STATE OF NORTH CAROLINA
DEPARTMENT OF TRANSPORTATION

Subject: Application for Modification to Section 404 and Section 401 permits and Neuse Buffer Certificate for the Northern Wake Expressway (I-540) from US 1 to US 64 in Wake County, Division 5. State Project No. 8.2401701, Federal Aid Project No. F-123-1(1), TIP No. R-2000 F&G; \$475.00 Debit Work Order 8.2401701, WBS Element No. 34365.1.1. NCDENR-DWQ Water Quality Certification Project No. 030114 and USACE Action ID 199920387.

The purpose of this submittal is to request a modification to the Section 404 permit and Section 401 Water Quality Certification and Neuse Buffer Certificate, specifically for Sections F&G. The modification for the permit is for several changes to jurisdictional and buffer impacts through construction modifications and to state discrepancies found by NCDOT personnel between the permit drawings and the construction plan sheets.

REV. 05/14/04
SHEET 30 OF 90

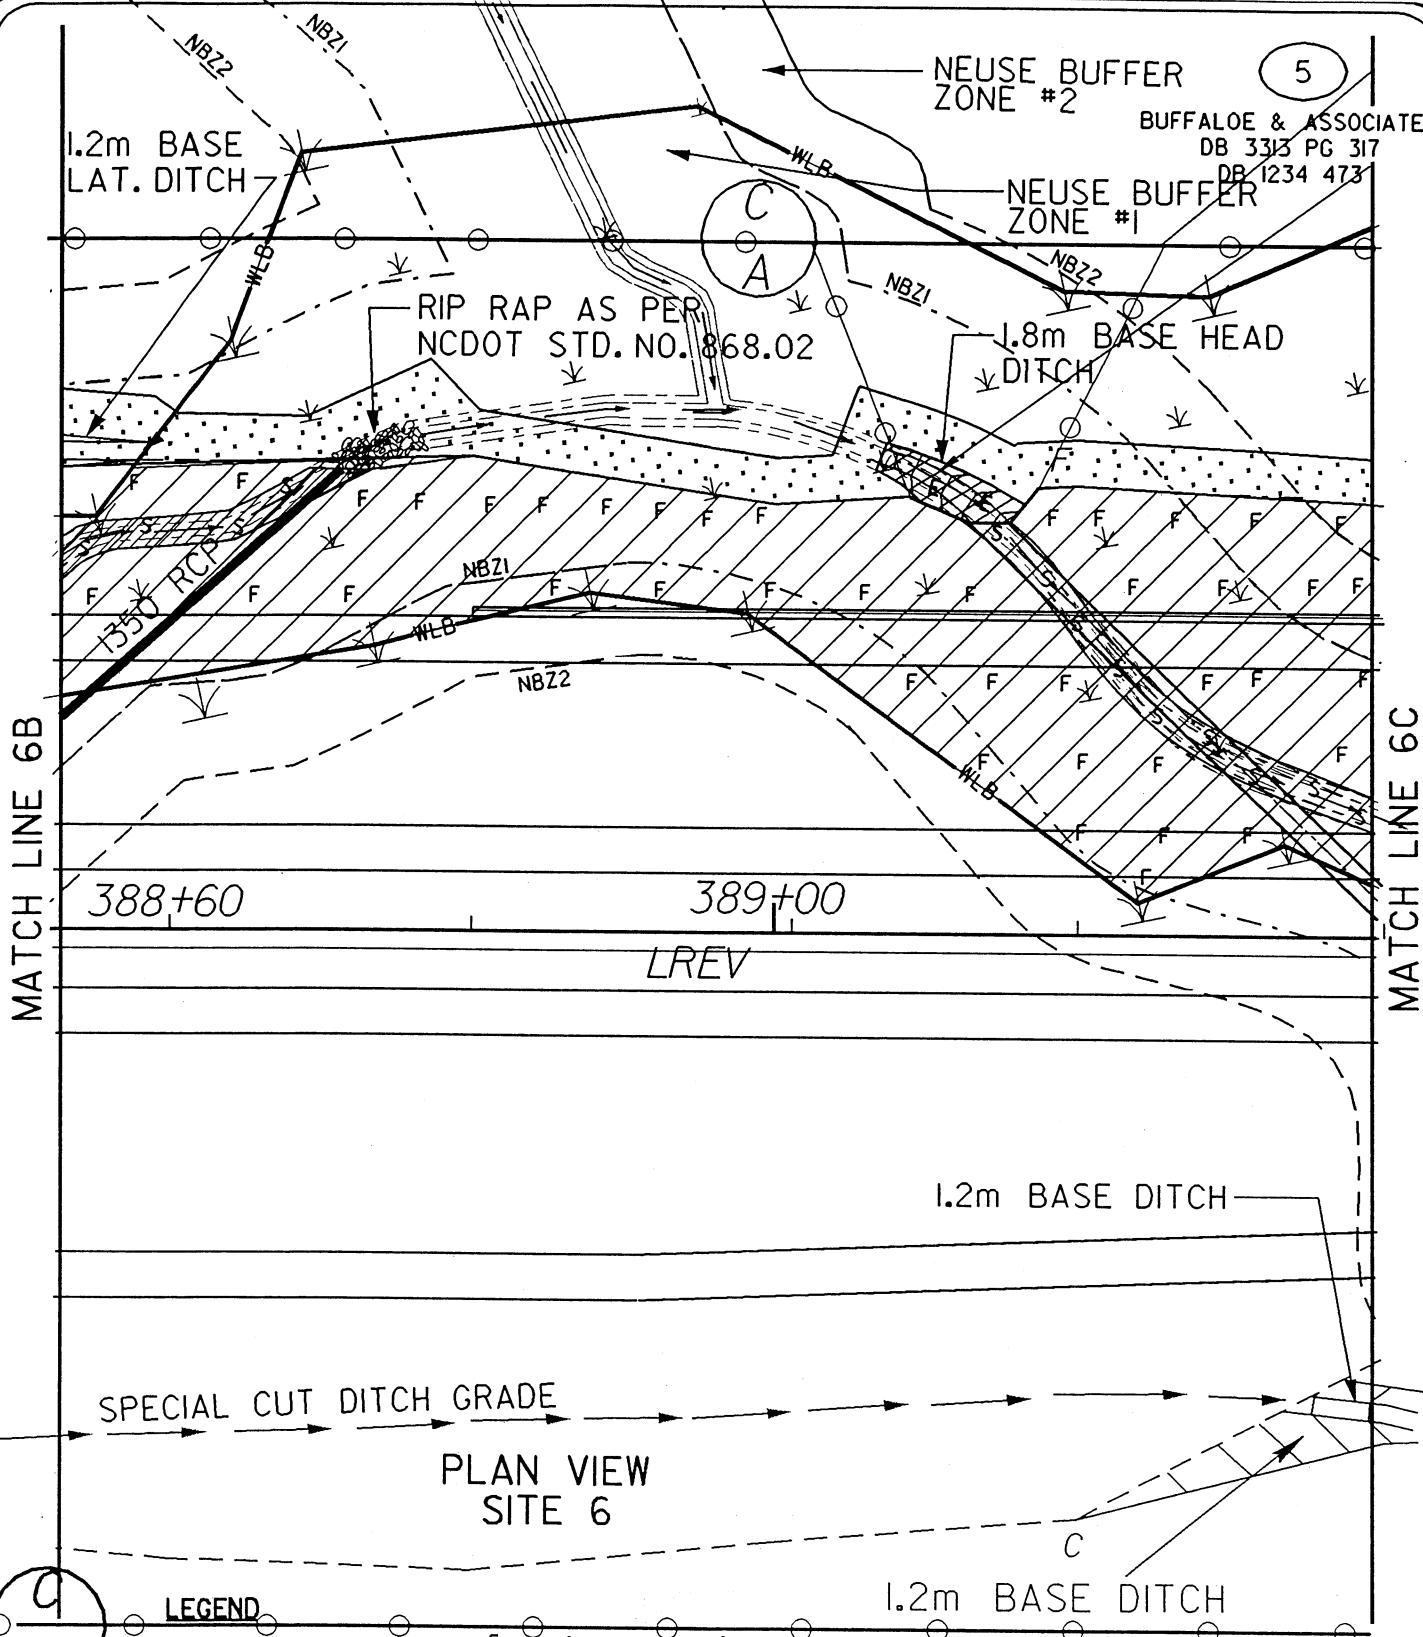
Permit Drawing 30/Plan Sheet 15/Site 6

Original permit drawing depicted excavation in a wetland outside the project construction limits. This impact is more correctly described as a drained wetland instead of excavated. The permit drawing is revised as such. There are no changes in jurisdictional impacts.

SCALE AS SHOWN SHEET 31 OF 90

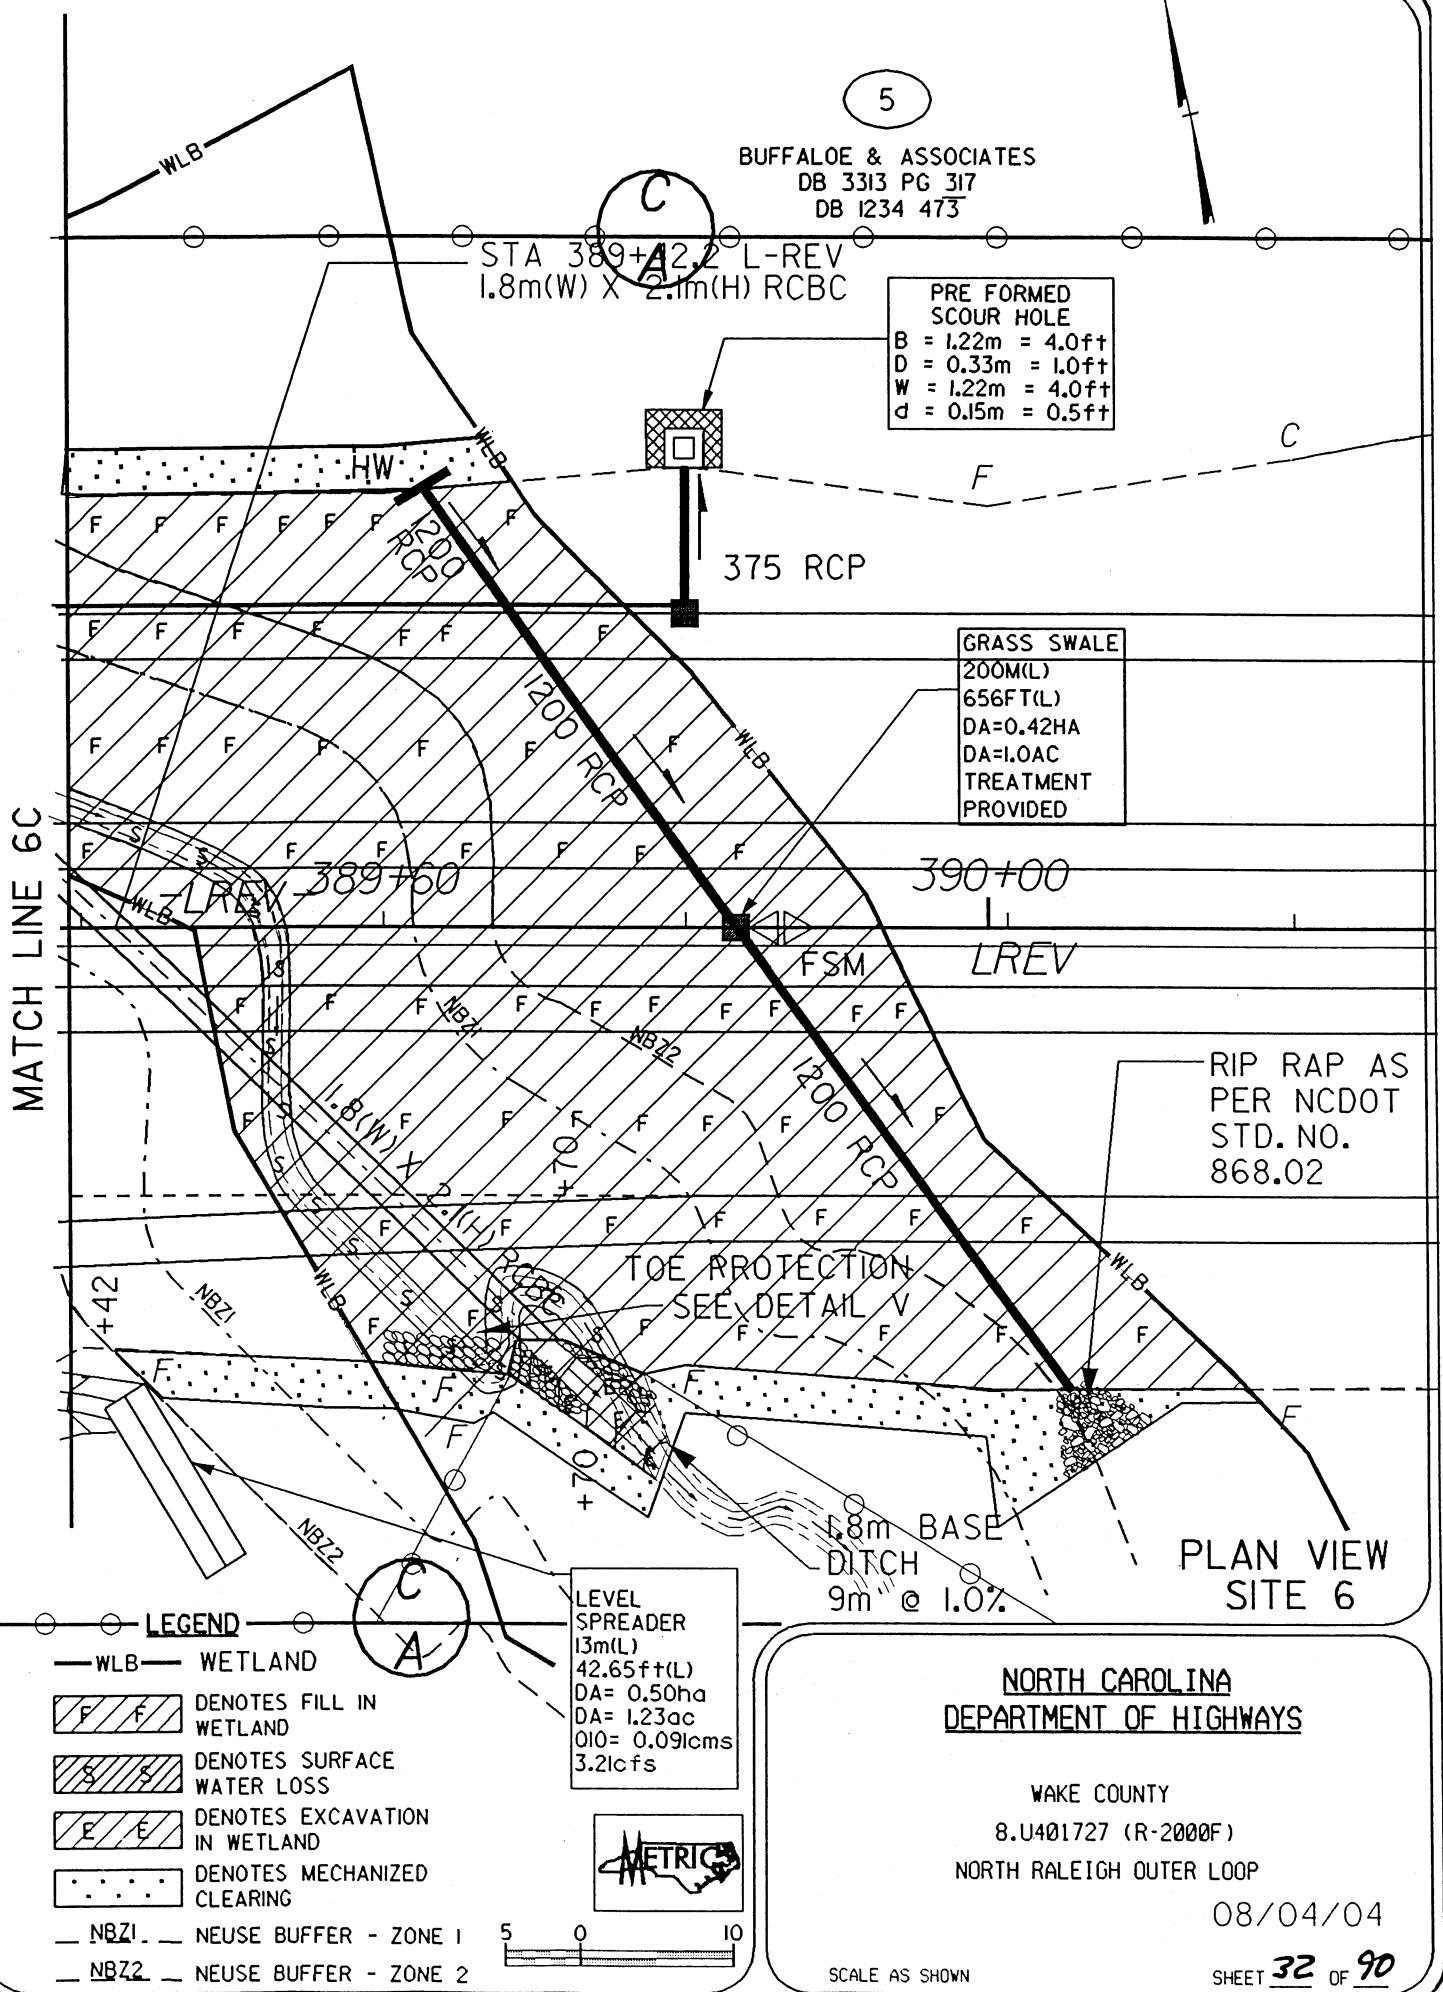
Permit Drawing 31/Plan Sheet 15/Site 6

The permit drawing, Sheet 31, will be revised to reflect the proposed Shoulder Berm Gutter. No change in jurisdictional impacts. Revised only to agree with plan sheets.

Fill slopes adjacent to the culvert at Station 389+10 have been revised to reflect the change in fill slopes from 3:1 to 2:1. The reduction of wetlands at this site was too small to change on the summary sheet although a small amount of fill in buffers was reduced and reflected on the summary sheet. The reduction in impacts to buffers in Zone 1 are 174 sq ft and in Zone 2 are 261 sq ft.

SHEET 41 OF 90

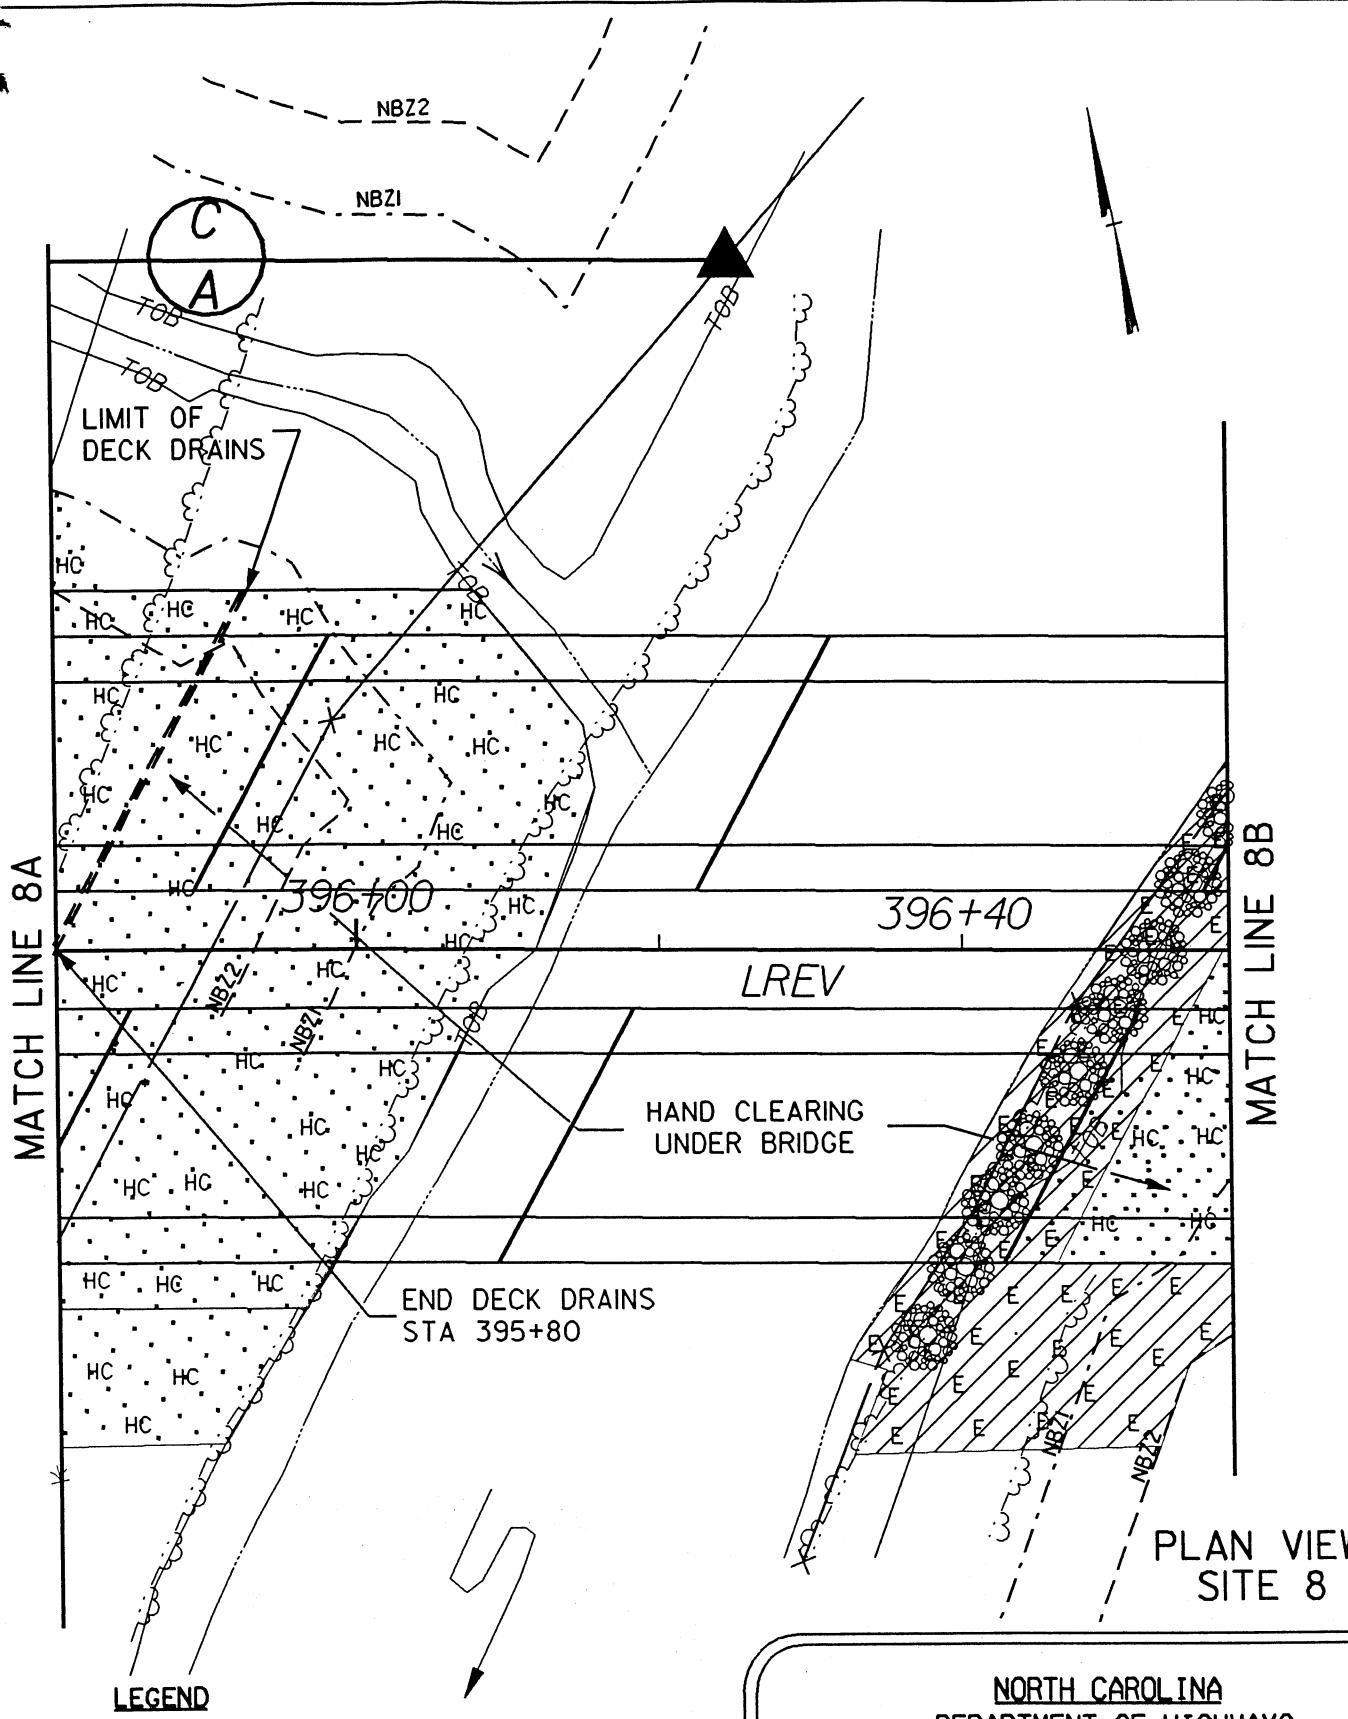
Permit Drawings 41, 42, 43, 47/Plan Sheet 17/Site 8

The Permit Drawing 41 and 47 will be revised to reflect the additional temporary impacts to wetlands and for hand clearing impacts in buffers for the extension of the timber mats to allow installation of the proposed Class II Rip Rap End Bent Slope Protection. Additional temporary impacts to wetlands are 0.21 acres (ac) and additional impacts of hand clearing in buffer Zone 1 are 1176 sq ft and buffer Zone 2 are 2483 sq ft. Buffer impacts for bridges are allowable. No mitigation will be required for wetlands or buffers.

REV. 07/19/04
SHEET 42 OF 90

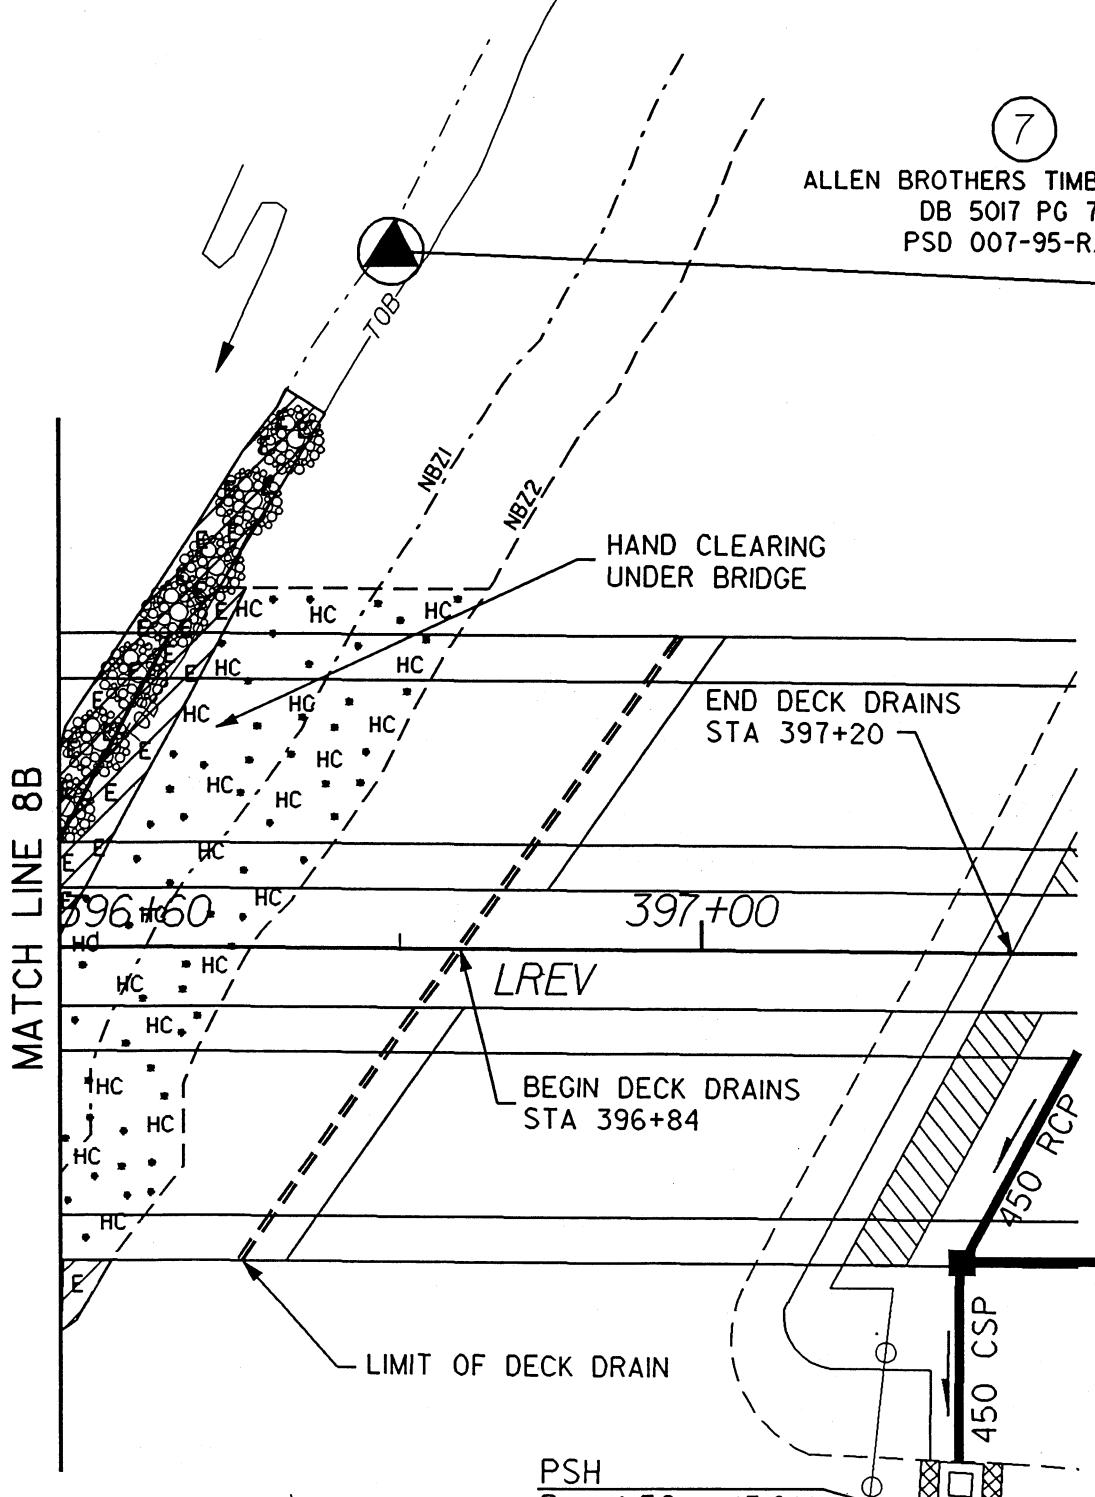
Permit Drawings 42 and 43 and buffer impacts will be revised to reflect excavation in Zone 1 along the East Bank of the Neuse River to allow for excavation and shaping of the existing bank and installation of the proposed Class II Rip Rap. The amount of excavation is 4835 sq ft in Zone 1. The hand clearing in the buffers was then reduced by 3354 sq ft.
